GFA AIRWORTHINESS DIRECTIVE

SUBJECT: Flight controls:- Failure of elevator bellcrank bearing attachment bolt.

GFA AD-648	ISSUE: 1	26 June 2007	Page 2 of 7
------------	----------	--------------	-------------

Technical Note
No. 348/19, 843/26

DG Flugzeugbau GmbH
Working instruction No. 1 for TN348/19

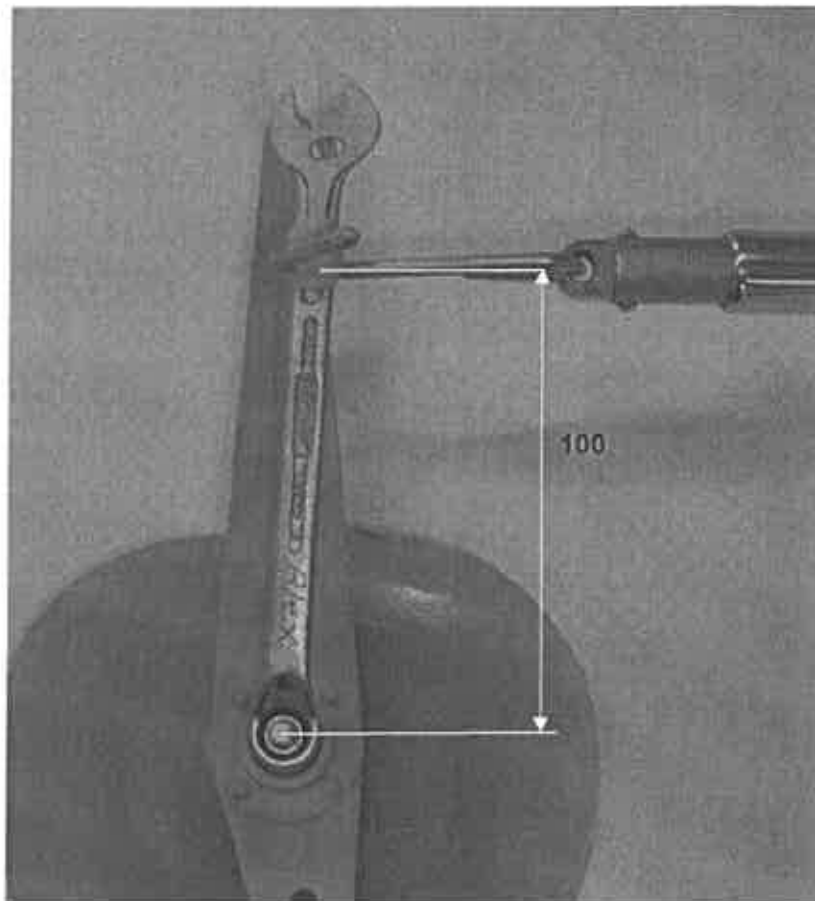
Check of the actual torque of the nut which fixes the bellcrank 5St19 to the bolt of the bearing stand

1. Derig the glider and remove the baggage compartment floor and back cover plate.
2. Identify the bellcrank 5St19 referring to diagram 1 of the maintenance manual.
3. The check should be executed with a torque wrench equipped with a 10 mm socket wrench.

Adjust the torque wrench to 3 Nm (2.2 ft.lb.) and try to retorque the nut. If retorquing was possible the actual torque was too low and instruction 2 of TN359/19 (replacing the bolt) must be executed prior to the next flight.

4. If no torque wrench is available which can be adjusted to a torque of 3 Nm the check may be executed with a 10mm spanner according to the photo below,
Fix a spring balance measuring range 50N (5kg, 10 lbs.) or 100 N (10 kg, 200 lbs.) at a distance of 100mm (4 in.) from the centre of the nut to the spanner e.g. with tape.
Retorque the nut with a force of 30 N (3 kg, 6 lbs.).
If retorquing was possible the actual torque was too low and instruction 2 of TN359/19 (replacing the bolt) must be executed prior to the next flight.
5. If the nut had still a torque of 3 Nm or higher and if you don't want to replace the bolt immediately retorque the nut with a torque wrench adjusted to a value of 12 Nm(9 ft. lb.)
6. Execute a control check.
7. Reinstall the baggage compartment floor and back cover plate.

DG Flugzeugbau GmbH
Working instruction No. 2 for TN348/19

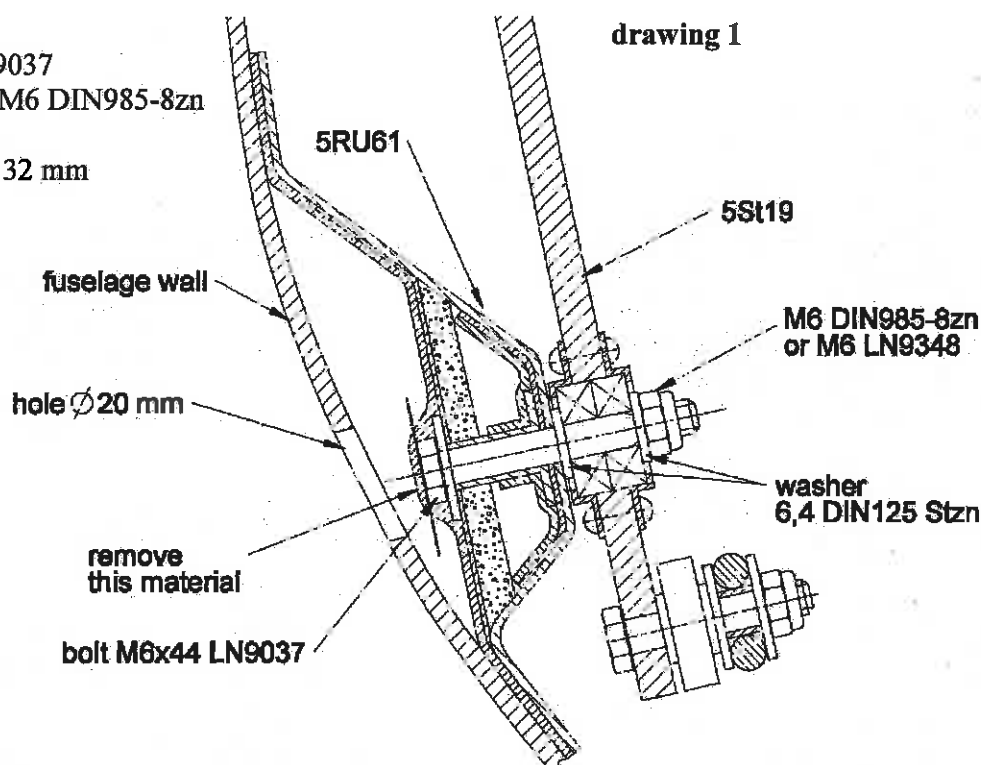
Replacing the bolt of bearing stand 5RU61

1. Derig the glider and remove the baggage compartment floor and back cover plate.
2. Identify the bellcrank 5St19 referring to diagram 1 of the maintenance manual.

3. Use a powerful lamp to illuminate the fuselage from the inside. Mark the edges of the gluing flange of bearing stand 5RU61 on the outside of the fuselage.

4. Drill a 6mm (1/4 in.) hole in the centre of the marking according to drawing 1. Enlarge this hole with a 10 mm (3/8 in.) drill. Then enlarge it to a dia. of max. 20 mm (6/8 in.) with a 6mm (1/4 in.) hard metal cutter. Shift the centre of the hole to the centre of the bolt head while enlarging the hole.

5. Remove any resin and the GFRP fabric located on top of the bolt head with the hard metal cutter. Don't remove the resin and the fabric from the spanner flats of the bolt head.

6. Heat the bolt head up to approx. 150°C (300° F) with a fan heater. The fan heater must be equipped with a nozzle with an inside diameter of approx. 5mm.

7. Push the bolt from the inside out of the fuselage using a steel hammer..
8. Push in the new bolt so that its spanner flats slip into the recess from the existing bolt head.

9. Reinstall bellcrank 5St19, use a new self locking nut.
10. Retorque the nut with a torque wrench with a torque of 12 Nm(9 ft. lb.)
11. Execute a control check.

12. Reinstall the baggage compartment floor and back cover plate.
13. The hole in the fuselage wall shall not be closed permanently. It shall remain as an access hole.
Close the hole with a suitable sticker.
